AIR RESOURCES BOARD

Executive Order G-70-17-A

Relating to the Modification of the Certification of the
Emco Wheaton Balance
Phase II Vapor Recovery System

Exhibit 1

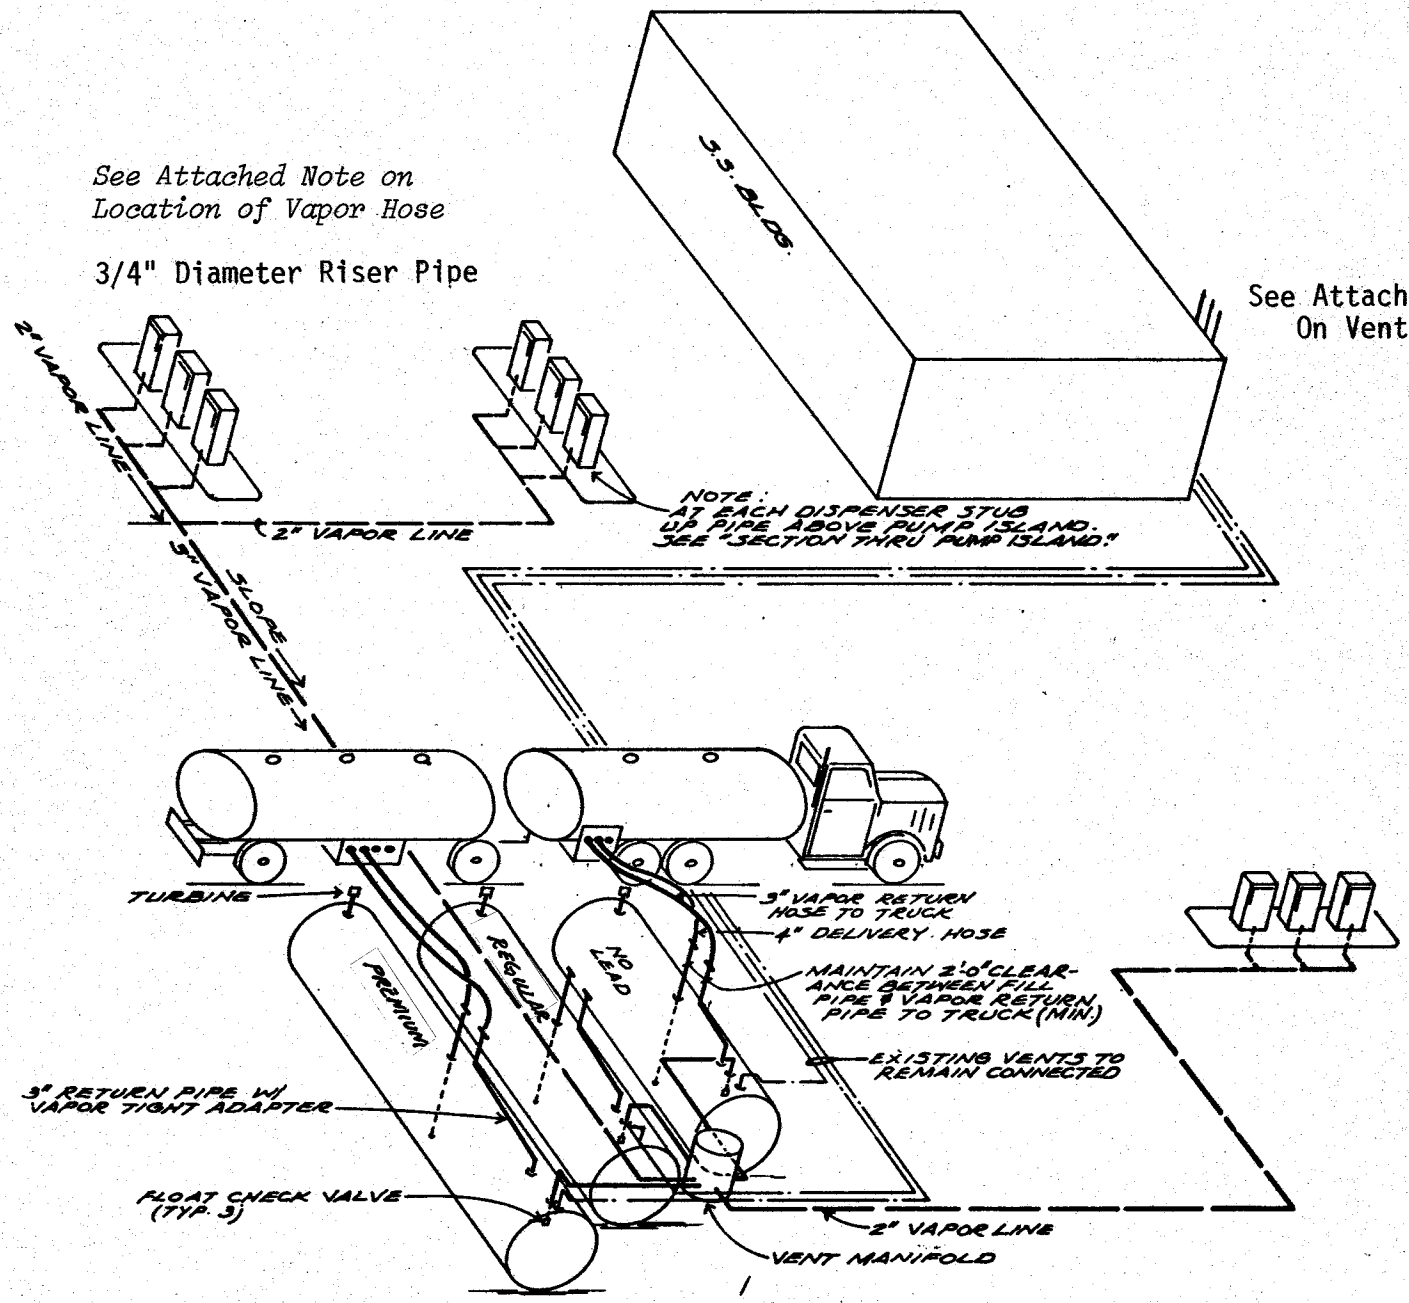
IT IS ORDERED AND RESOLVED: That the certification issued on April 17, 1978, for the Emco Wheaton Balance Phase II vapor collection and disposal system is hereby modified to specify nozzles which are capable of fueling all vehicles as required in the Air Resources Board certification procedures adopted March 30, 1976, and amended August 25, 1977, and to specify 8 foot long vapor hoses to provide for better clearance of liquid blockages from vapor hoses. The system hereby modified is certified for attendant and/or self-serve use at gasoline service stations in conjunction with Phase I vapor recovery systems which have been certified by the Air Resources Board. The system is described in Exhibits 1, 2, and 3 attached hereto.
